ADDENDUM TO THE BID DOCUMENTS	Page Number One (1)	Number of Pages Three (3)
<u>Addendum No:</u> ONE (1)	<u>Date this Addendum Issued:</u> May 3, 2019	
<u>Issuing Office:</u> Matanuska-Susitna Borough Purchasing Division 350 East Dahlia Avenue Palmer, Alaska 99645 Phone (907) 861-8601 Facsimile (907) 861-8617	<u>Previous Addenda Issued:</u> NONE Number Date of Issue _____ _____ _____	
Return Acknowledgment To: Issuing Office Bid Title: Houston Middle School Ceiling Tile Removal and Selective Demo Bid No: 19-107B	<u>Date and Hour of Bid Opening:</u> As Advertised: May 10, 2019 @ 3:00 PM Revised by Addenda No. <u>NA</u> Revised to: <u>NA</u>	
<p>The following corrections, changes, additions, deletions, revisions, and/or clarifications are hereby made a part of the Contract Documents. In case of conflicts between this Addendum and previously issued Documents, this Addendum shall take precedence. The Bidder must acknowledge receipt of this Addendum in the space provided on the Submittal Page. Failure to do so may subject the Bidder to disqualification.</p> <p>This addendum is being issued to clarify certain aspects of the original Bid Documents and Scope of Work.</p> <p>Question #1: Has

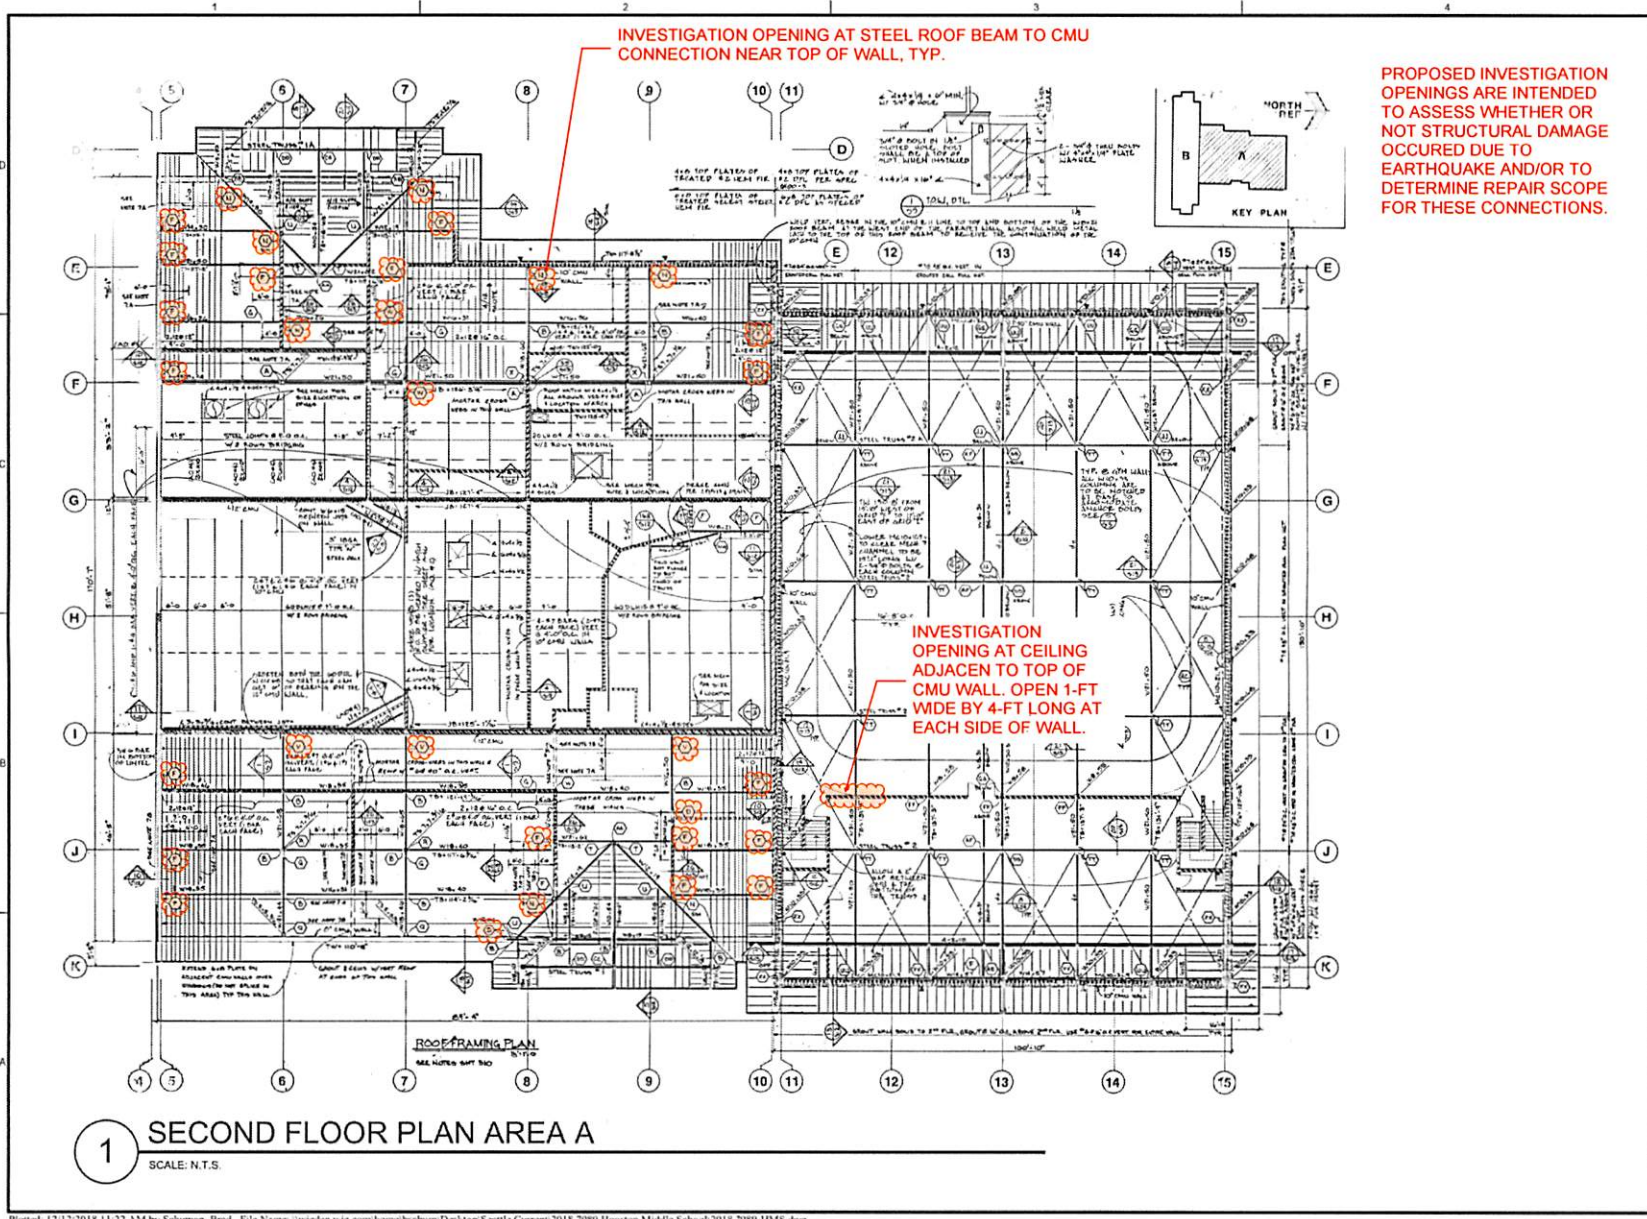
PROPOSED INVESTIGATION OPENINGS ARE INTENDED TO ASSESS WHETHER OR NOT STRUCTURAL DAMAGE OCCURRED DUE TO EARTHQUAKE AND/OR TO DETERMINE REPAIR SCOPE FOR THESE CONNECTIONS.
